SUNBELT RENTAL BUILDING ADDITION JSP14-68

PLAN REVIEW CENTER REPORT

SUBJECT: Sunbelt Rental Addition, JSP14-0068, Traffic Review of 2nd Revised Preliminary Site Plan, PSP15-0011

Attachment: New Conceptual Signing Plan by CZ

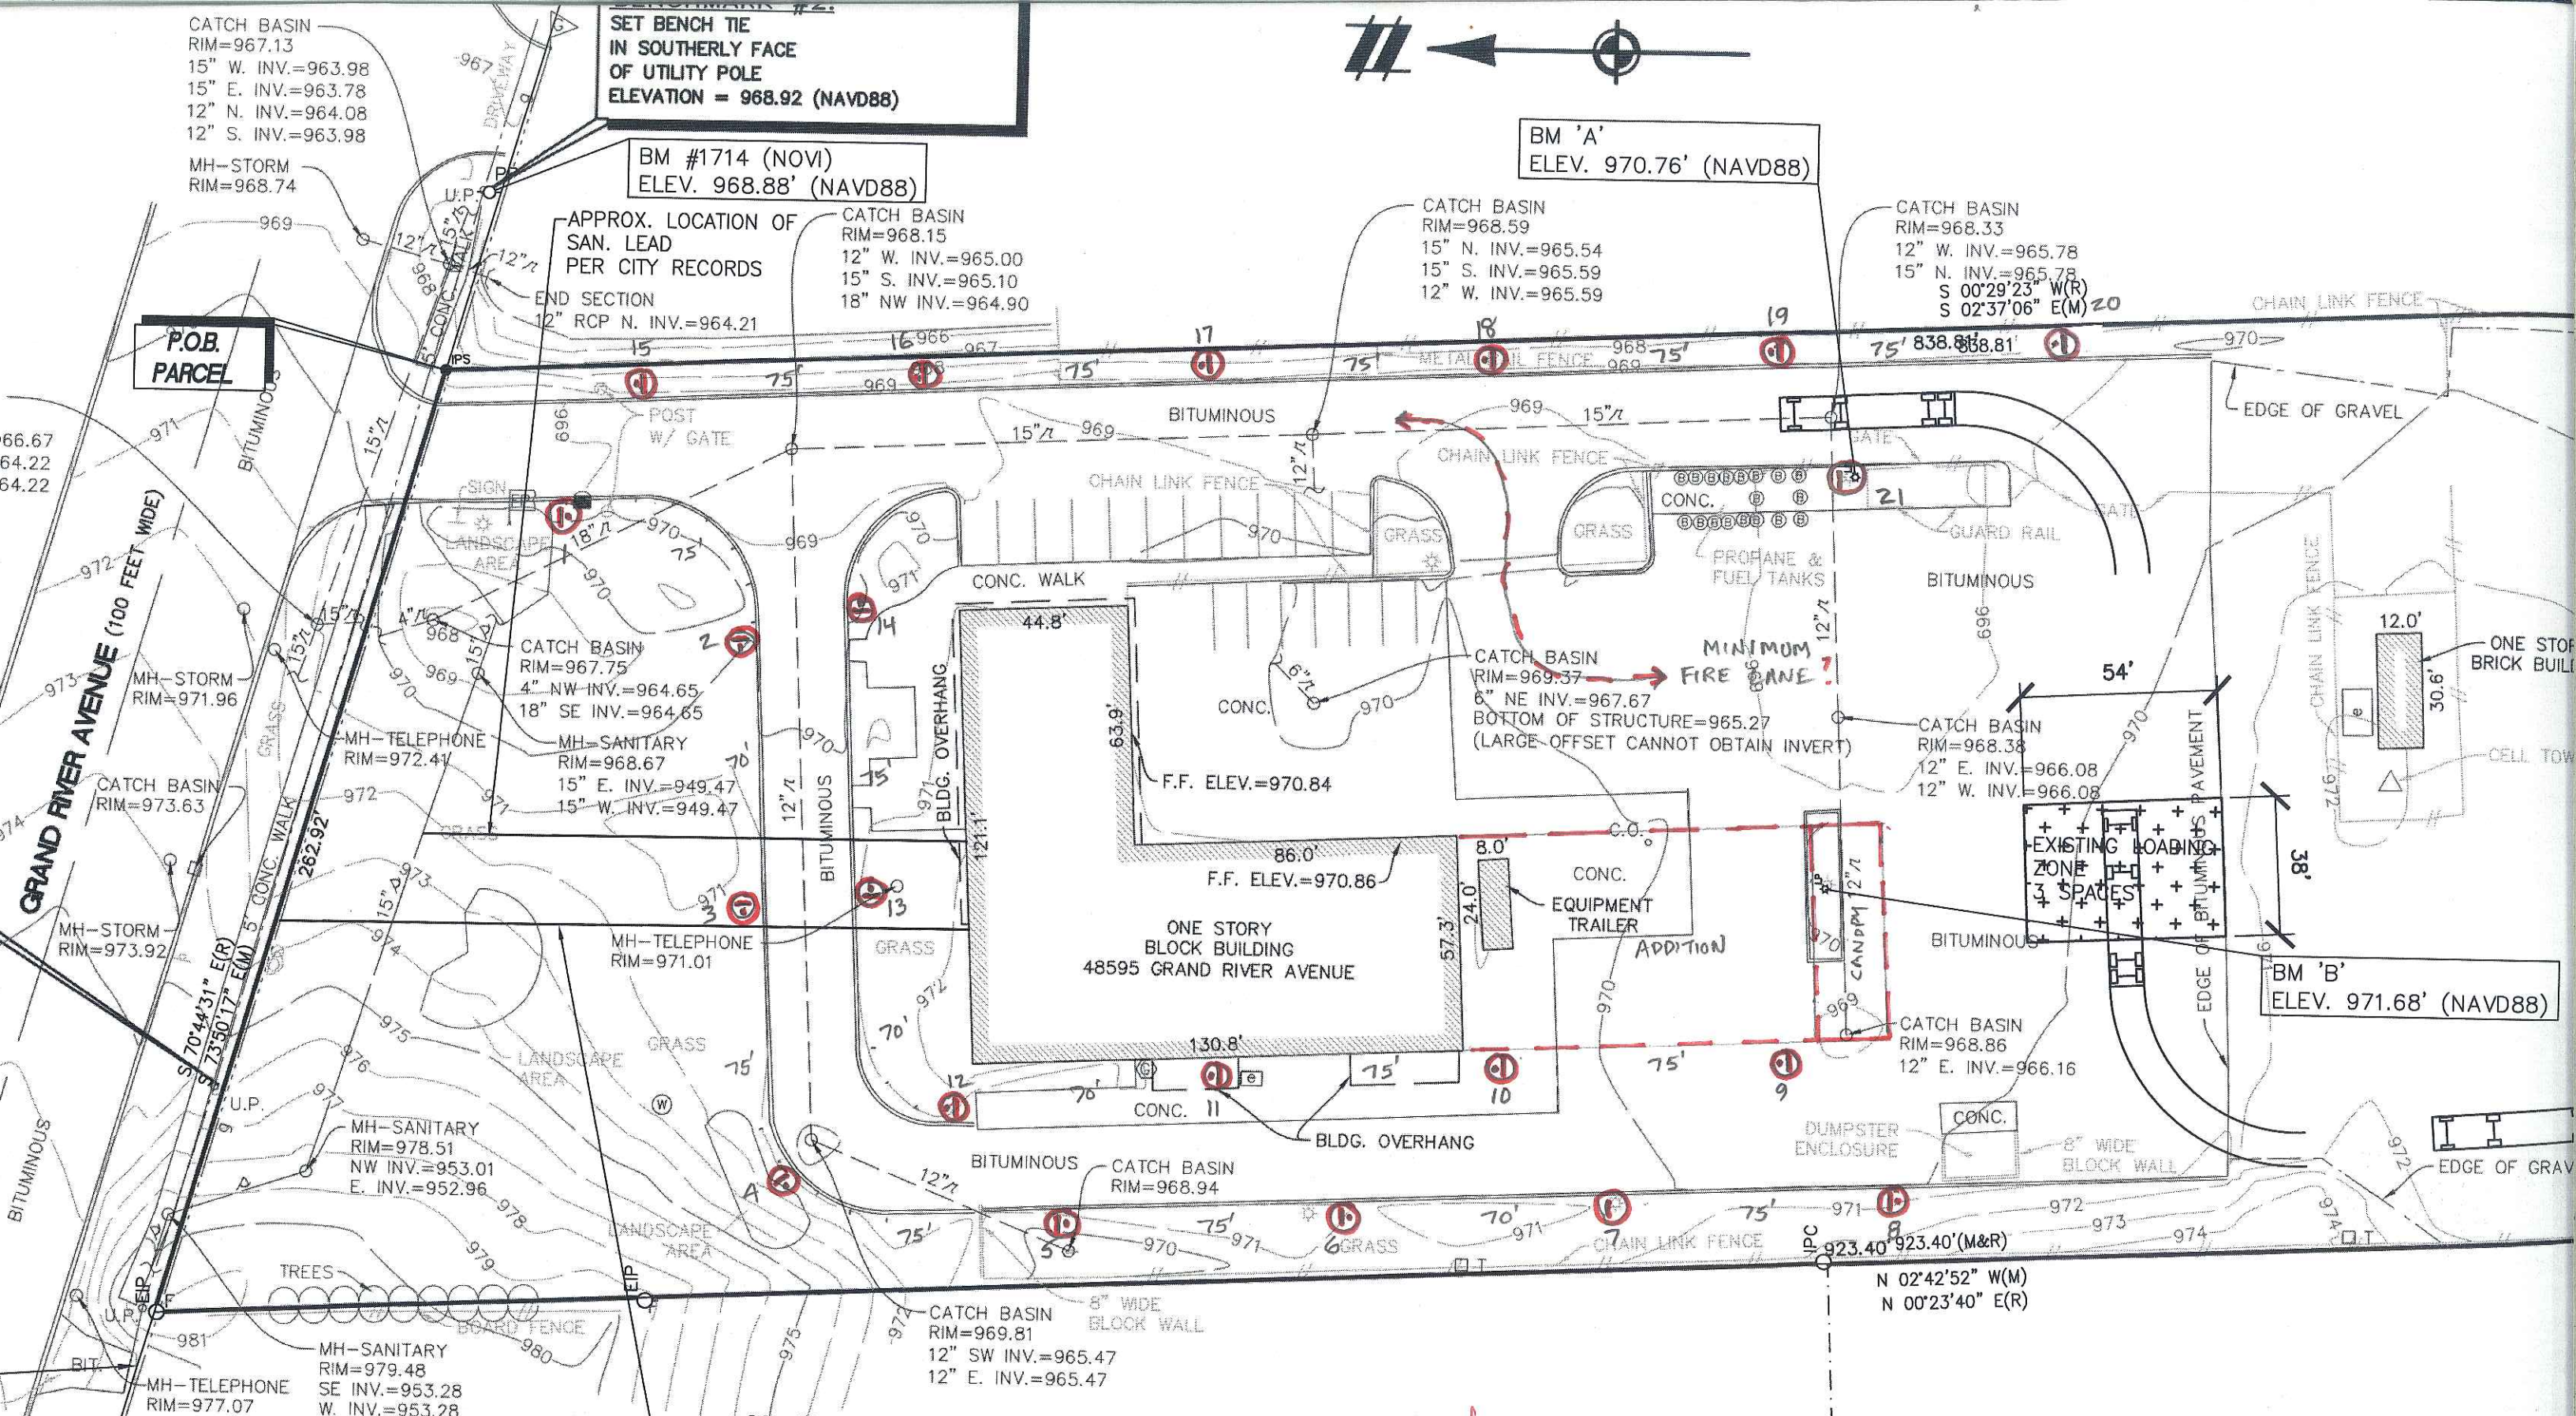
8. Based on the previous out-of-scale plan, we had estimated that a total of 20 NO PARKING FIRE LANE signs would be needed to meet the requirements of Sec 15-17 of the City's Fire Prevention and Protection Ordinance. Our earlier review quoted the relevant ordinance language, which indicated that such signs are to be "erected no further than seventy-five (75) feet apart in all areas designated as fire lanes... **All fire lane signs shall be placed at a right angle (ninety (90) degrees) to the designated fire lane so that they may be readily observed by vehicular traffic.**" **The plan now under review shows such signs parallel rather than perpendicular to the curb, and the plan must therefore be revised accordingly.**

9. Our previous letter also indicated the need for NO PARKING FIRE LANE signs along the entire west façade of the expanded building, whereas the plan under review does not show any signs along the building south of its northwest corner – which are needed in order to serve northbound traffic along this fire lane. Also, the proposed sign spacings are highly irregular – scaling between 58 ft and 77 ft, with many in the mid-60s range – and generally closer than necessary. Since we now have a properly scaled site plan to review, we took the initiative to develop our own signing plan on the relatively clean "Existing Conditions" sheet (C-1 of 7). **To provide the needed coverage and improve the spacing of signs, our signing plan (attached) should be adapted to the final site plan, and the Signing Quantities table on sheet C-3 adjusted accordingly.** If the Fire Marshal agrees with our previous assumption that the designated fire lane can pass between the two raised end islands east of the building, a total of only 18 signs would be needed (two fewer than previously estimated). If the fire lane must pass to a point south of the new parking bay, a total of 21 signs would be required.

7. No comment.
8. The plans will be revised to represent signs that will be perpendicular to the curb.
9. The provided signing plan, that includes 20 signs, will be incorporated in the revised plans.
